Stage 1 Road Safety Audit

Blacksmiths Lane, Reed

The Turney Trust

SLR Project No. 406.V58297.00001

Appendix C Problem Location Plan

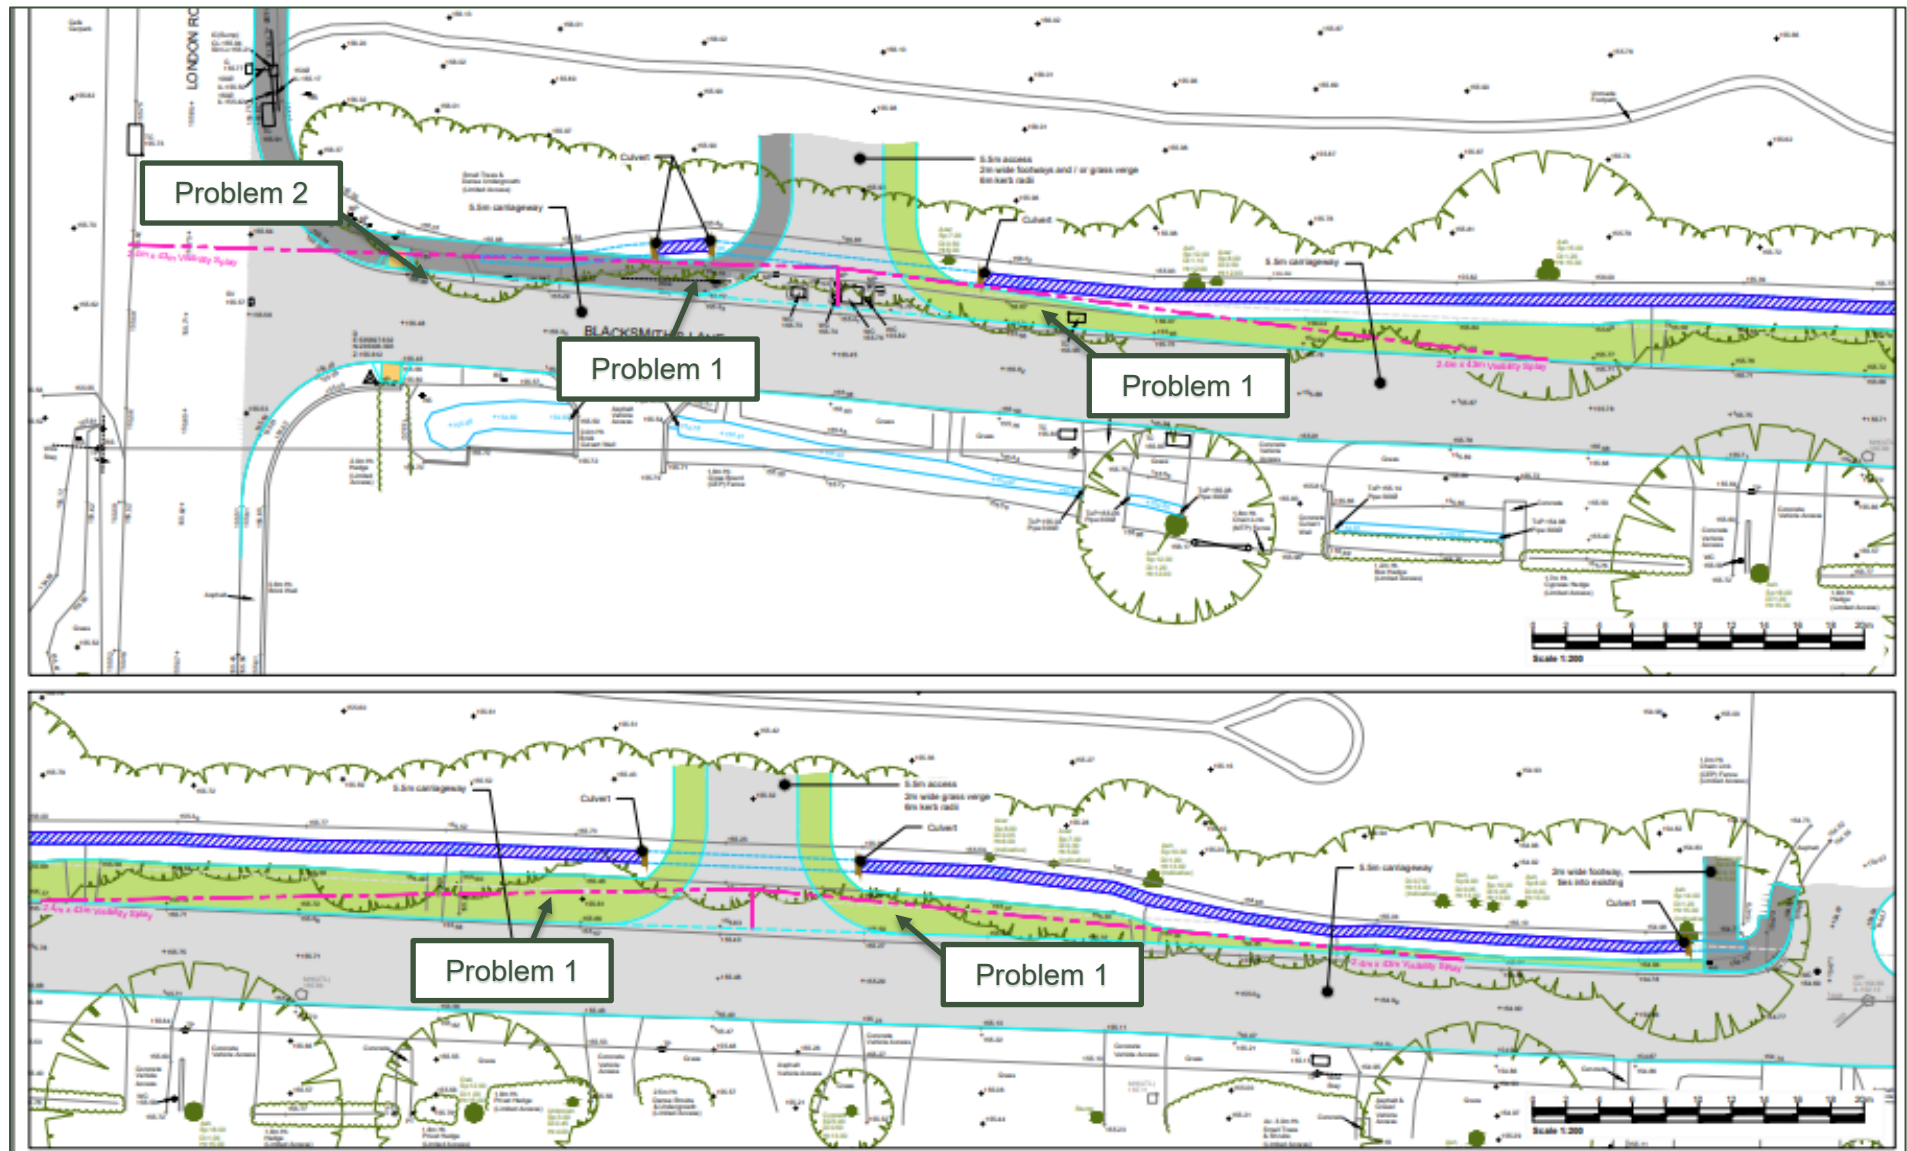
2.1 Problem 1

Location: Visibility Splays

Summary: Vegetation over spills into the visibility splay envelope, forming an obstruction to emerging visibility.

Failure to ensure visibility is kept clear of obstructions could result in side-swipe collisions between vehicles exiting the site and those travelling on the adjacent carriageway.

2.2 Problem 2

Location: Blacksmiths Lane junction with A10 London Road

Summary: The 30mph sign on the northern side of Blacksmiths Lane is obstructed on approach to the site, which could result in driver's failing to observe the change in speed limit. It is assumed by the Audit Team that this sign will be relocated to accommodate the new footway works.

Failure to ensure speed limit signage is correctly placed could result in collisions due to excessive speeds.

It is recommended that all vegetation within the extent of the visibility splays at both access points is maintained to a suitable height to ensure unobstructed visibility.

It is recommended that the identified sign be relocated to ensure full view on approach to the change in speed limit.
